Technical Service Bulletin no. 29

Created by: Lab.gruppen AB Service Department

Date: 20121124

Reference no: C-X

Modification instruction for AICO4B07b-FXX and below

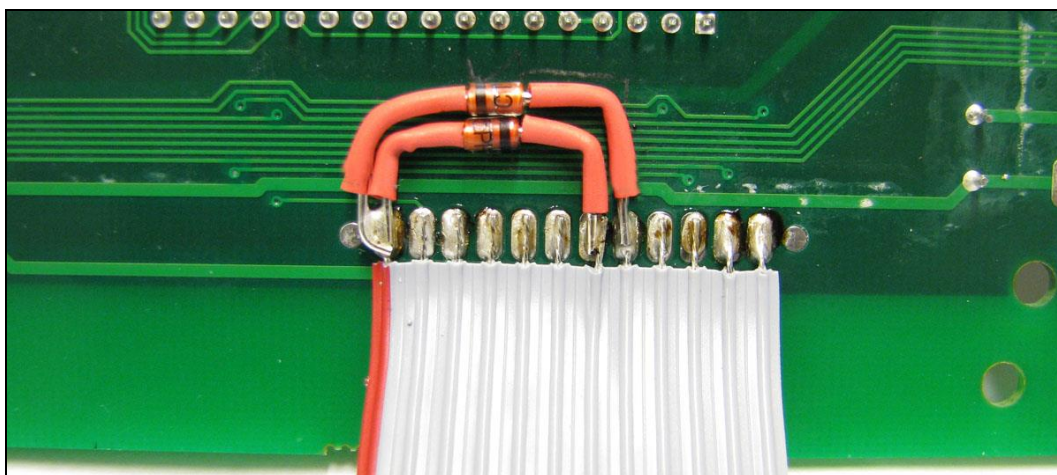
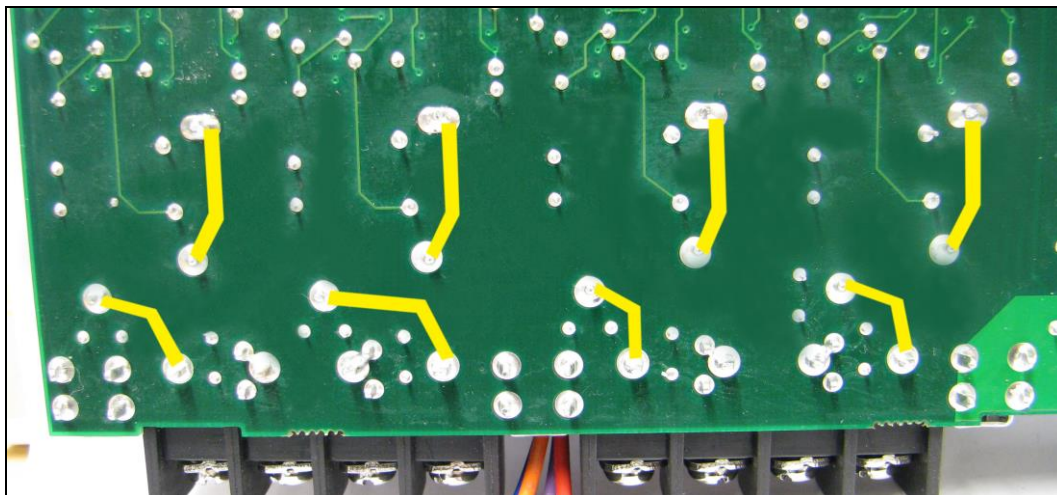
Added components: D422, D423, Diode Zener 20V 3.25W 5%.

Added components, D424, D425: Diode Zener 15V 1.3W 5%.	Hose!
--	-------

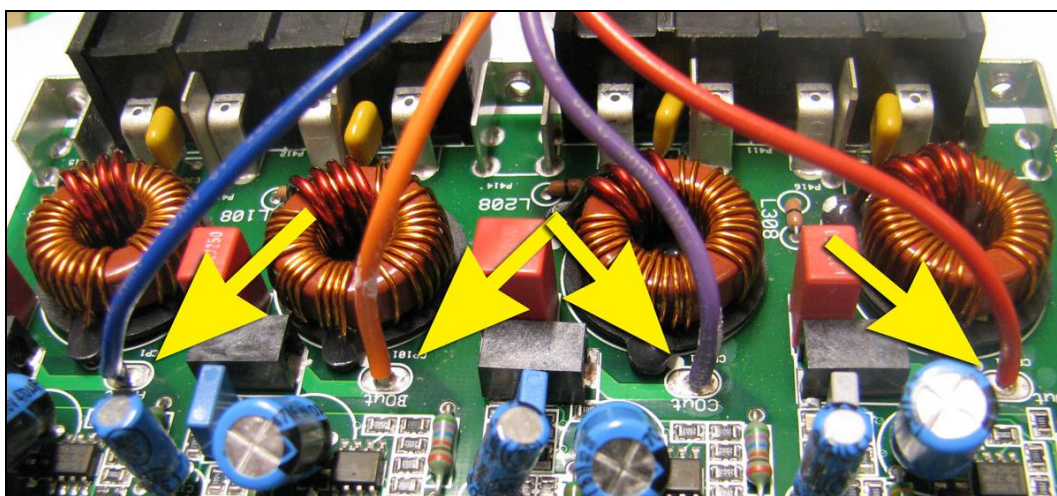
Solder jumper 0,8mm outside diameter. See yellow lines. Make sure short circuit to other solder pads is avoided!

Check that cables are still soldered correctly. (It may from heat from soldering on opposite side come out of its position.)

Instruction modification for AICO4BEXT07b-Fxx and below

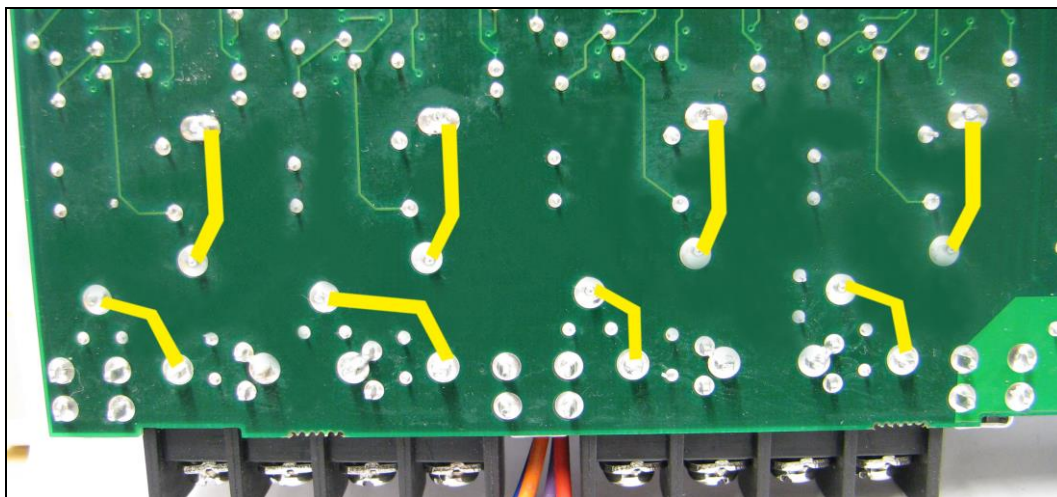
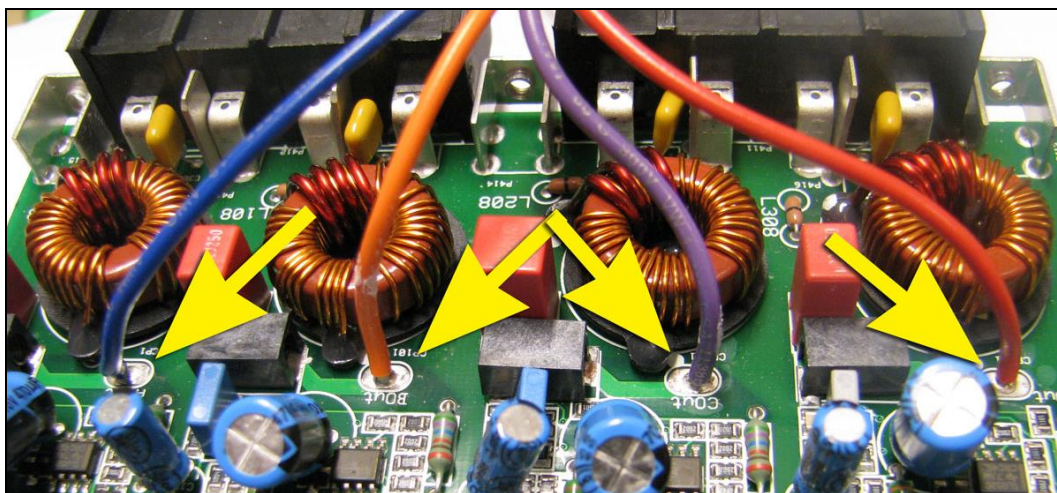
Solder jumper 0,8mm outside diameter. See yellow lines.
--	---

Check that cables are still soldered correctly. (It may from heat from soldering on opposite side come out of its position.)
--	--

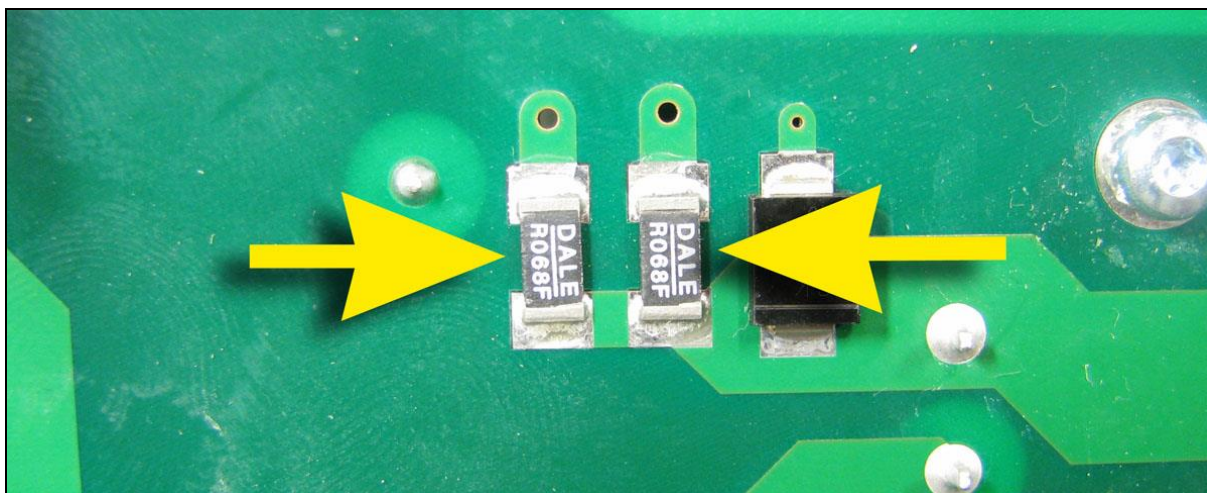
Replace resistor to 0R0681W1%2512. Vishay P/D number WSL2512R068FEA or WSL2512R068FEB		R36, R43
--	---	--	----------

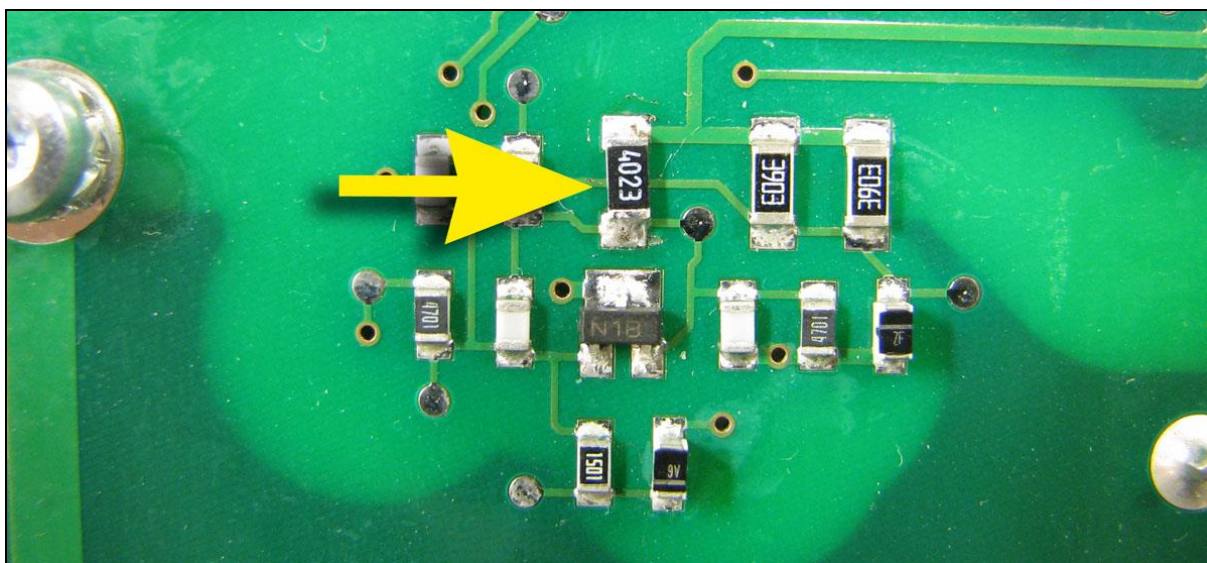
Replace resistor to 402K.250W1%1206		R103
--	-------------------------------------	--	------

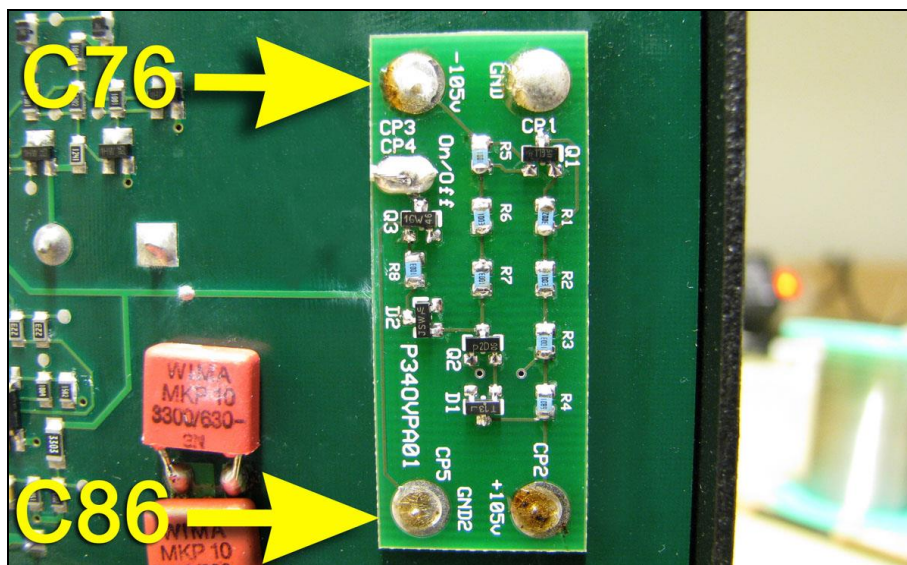
Mount pcb P34OVPA-ST01 at leg of capacitors C76 & C86. Solder pcb. Caution! Control soldering.		
--	--	--	--

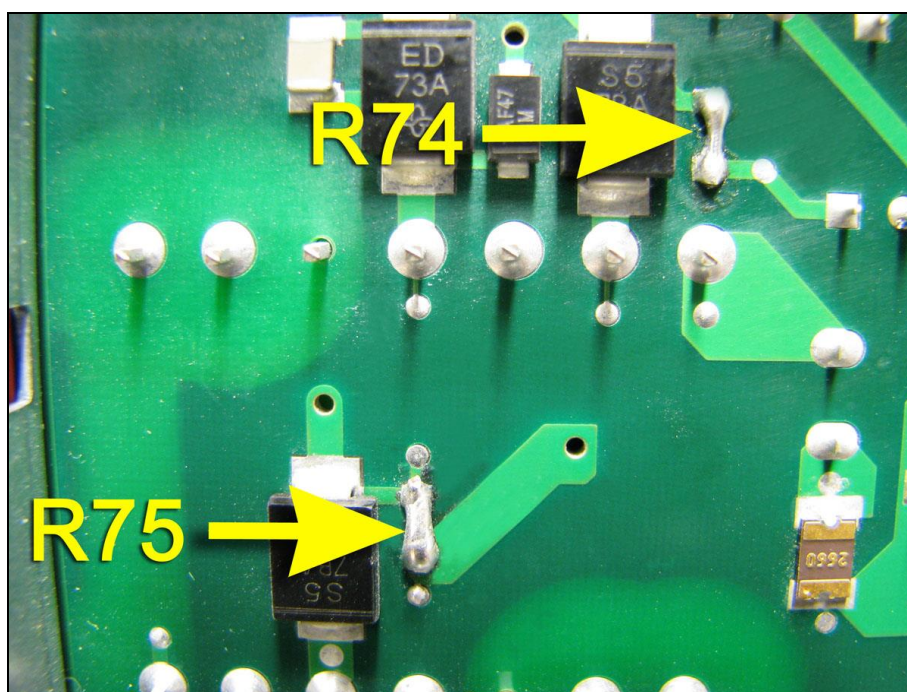
Remove R74-75. Solder Resistor Jumper Or D.8 according to picture		R74-75
--	--	--	--------

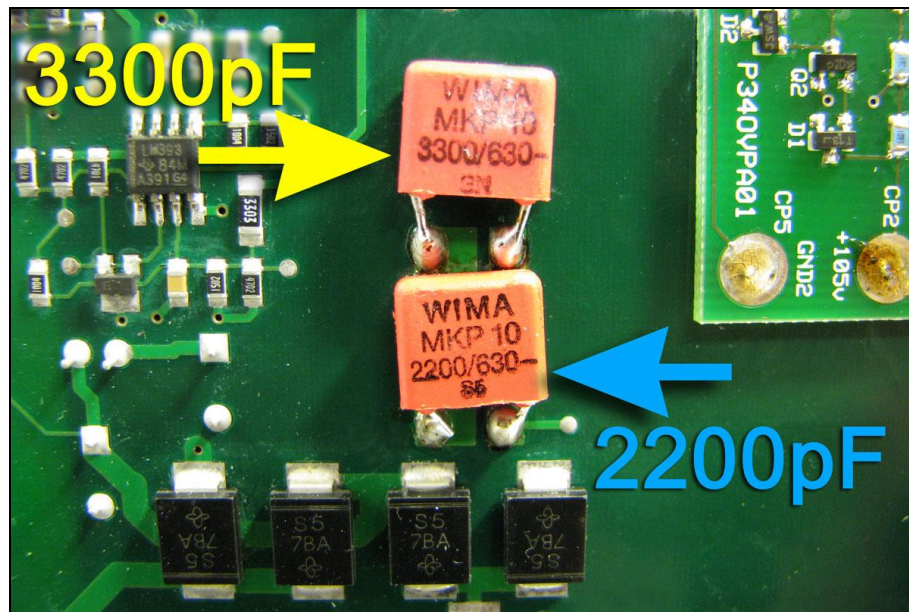
Remove Surface Mounted capacitor. Solder new capacitor according to picture.		D29, D28
--	--	--	----------

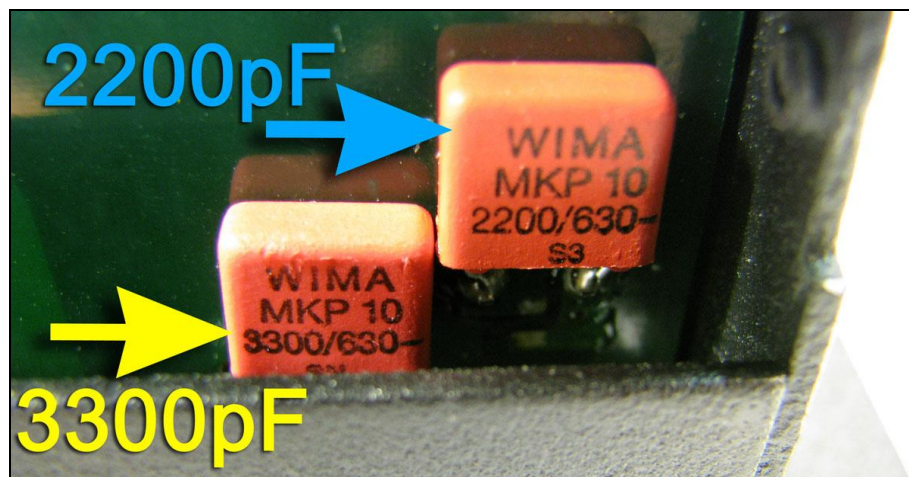
Remove Surface Mounted capacitor. Solder new capacitor according to picture		D27, D30
--	---	--	----------

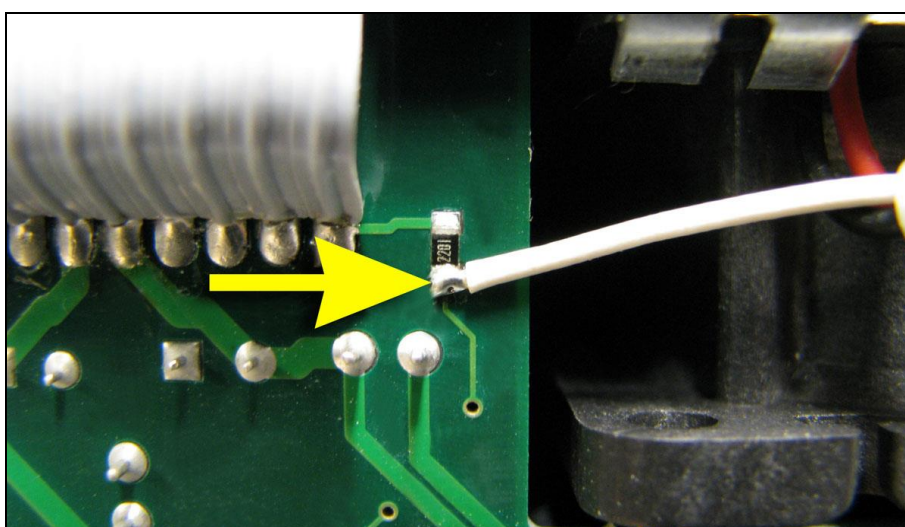
Solder Awg 24 cable at R51 according to picture. NOTE! (The cable has to be mounted on the marked side of the component)		
--	--	--	--

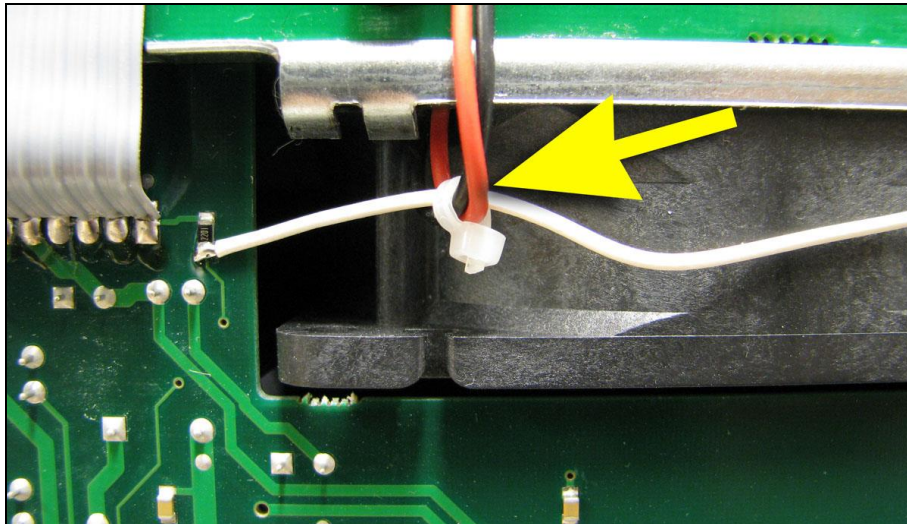
Place AWG 24 cable under Red & Black fan cables. Tie cables according to picture.		
--	--	--	--

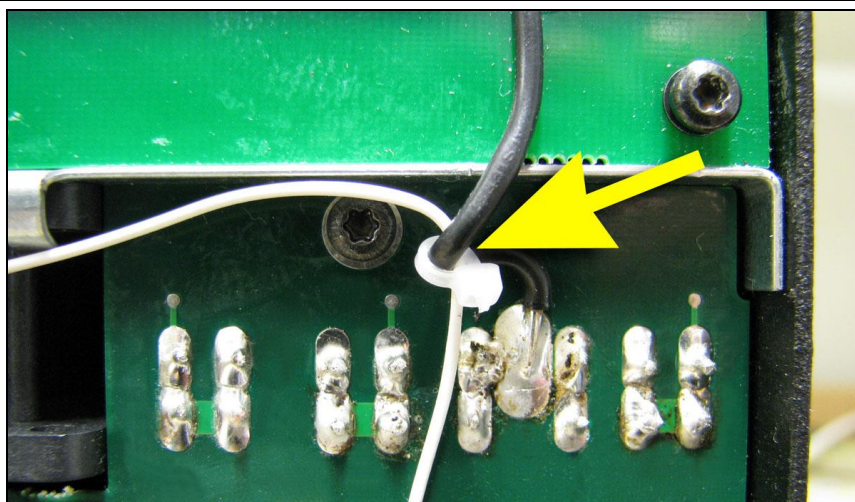
Place AWG 24 cable under Black ground cable. Tie cables according to picture		
--	---	--	--

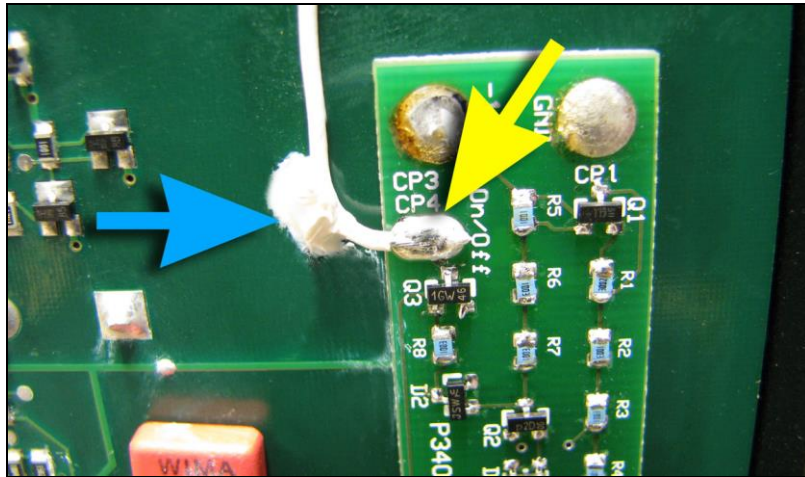
Solder AWG 24 cable at CP4. Apply Sikaflex at AWG 24 cable (se blue arrow)		
--	--	--

SP20F-F01 Mount Ferrite and apply glue if it's not mounted on D3.

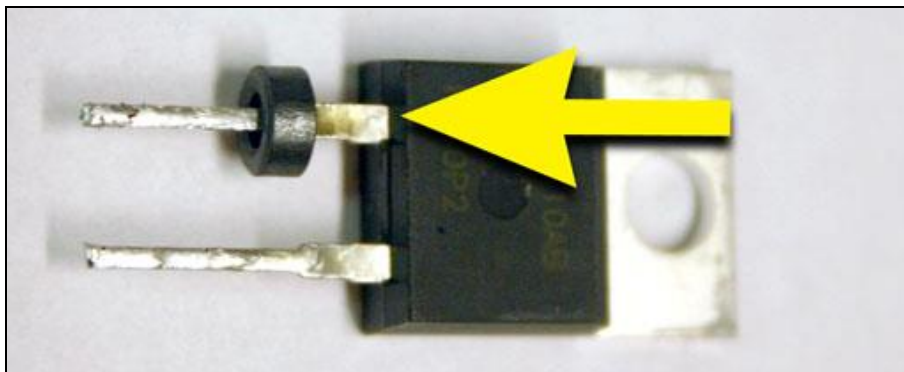
Mount Ferrite on D3 according to picture.		
--	---	--	--

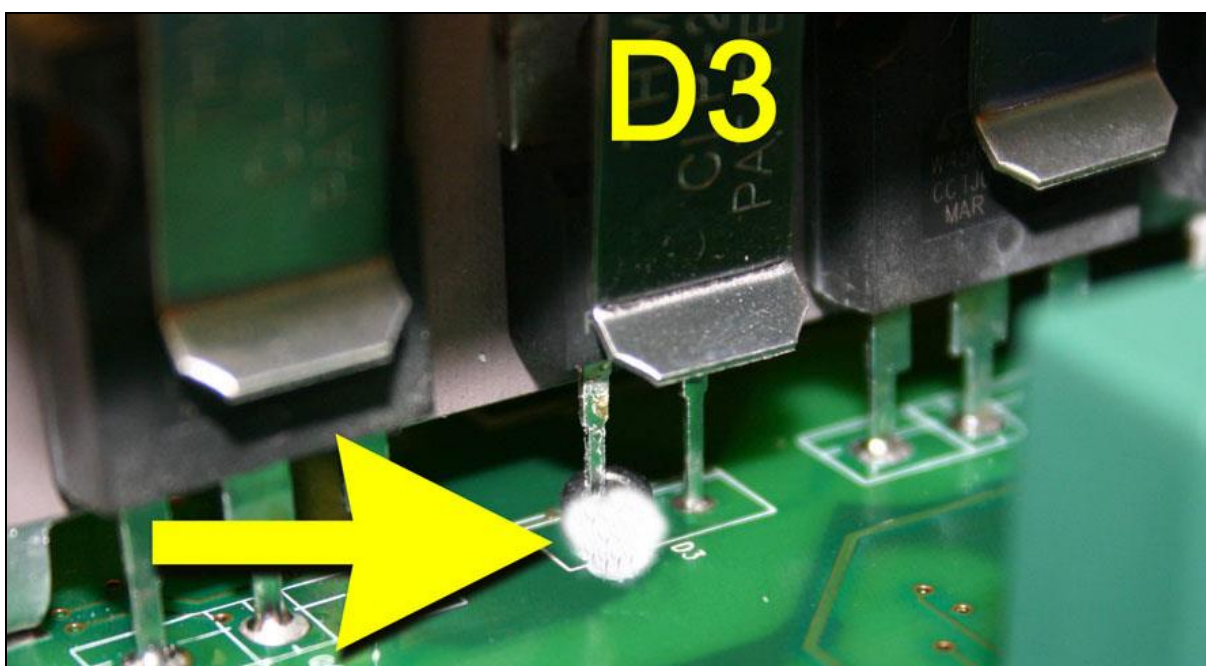
Fasten the bead component using a non conductive glue that withstand temperatures of at least 120°C according to picture.		
--	---	--	--

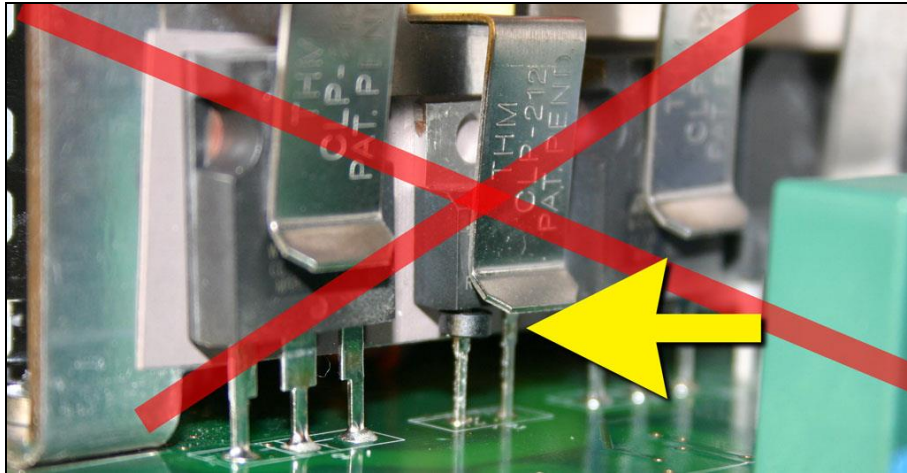
The ferrite must be fasten against the PCB.		
---	--	--

Instruction for A104D- P34001-D and below

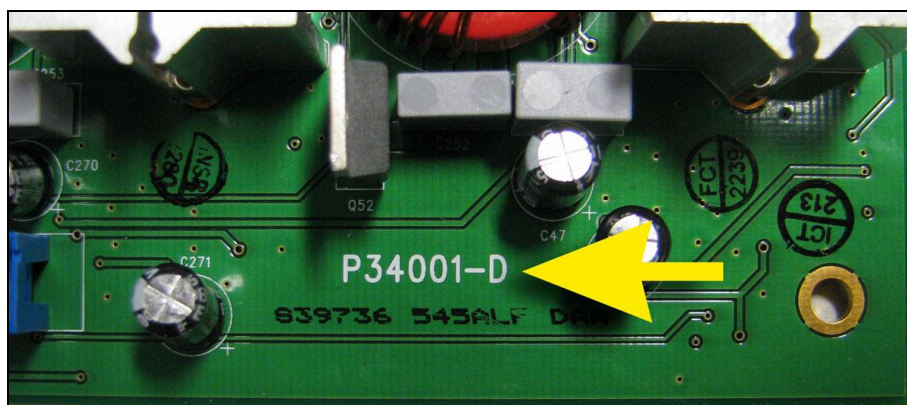
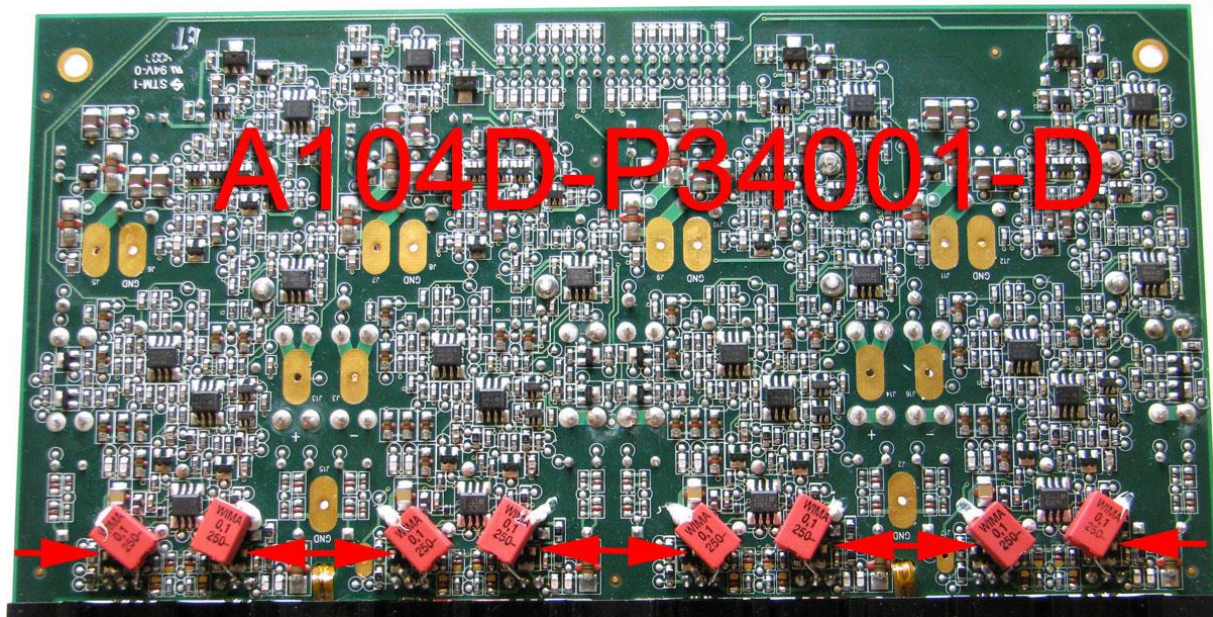
In the example in pic1, the “D” indicates the PCB revision number. Whenever you encounter a PCB revision number “D” or below, see if the capacitors are mounted like in Pic2 (see red arrows) then the board has been updated to the latest revision so you can continue repairing.

If they are not mounted you need to replace the A104D-P34001. See the spare parts list for the correct spare part.
